Perry Nuclear Power Plant Docket No. 50-440

Subject: Mid-cycle Revision to the Core Operating Limits Report

Mid-Cycle Revision of the PNPP Core Operating Limits Report

TITLE:	CORE OPERATING	LIMITS REPOR	T FOR TH	E PERRY	NUCLEAR :	POWER P	LANT UN	IT 1
	CYCLE 11 (RELO	AD 10)						
					:		•	
PDB -	F0001 /Rev. 13	MPL:	<i>J</i> 11	EFFECT	IVE DATE:	8	-29-06	·
SUMMARY	OF LAST CHANGE	E:						
Clarifi	cation of the	administrativ	e limit o	on MFLCI	R during	single	loop	
operati	ons.

Figure 3.2.2-7

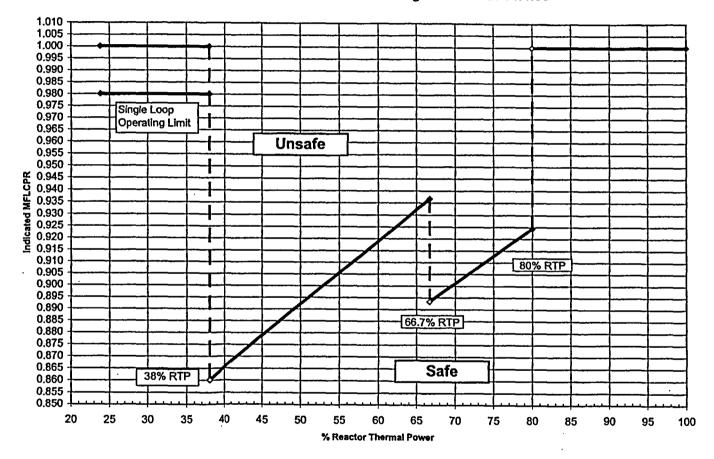
In the case where a Pressure Regulator is out of service and the plant is in Single Loop Operations, limit MFLCPR to the smaller of 0.98 and Figure 3.2.2-7, MFLCPR Limit With One Pressure Regulator Out Of Service.

The MCPR Safety Limit for Cycle 11 is 1.08 and the MCPR Safety Limit for Single Loop Operation is 1.10 <TECHNICAL SPECIFICATIONS 2.1.1.2> (Reference 3 and 17). During Single Loop Operation with 3D MONICORE monitor in "2 LOOPS ON" mode, the Maximum Fraction of Limiting Critical Power Ratio (MFLCPR) shall be equal to or less than 0.98. Use FTI-B0012 Single Loop Operation to implement this revised MFLCPR.
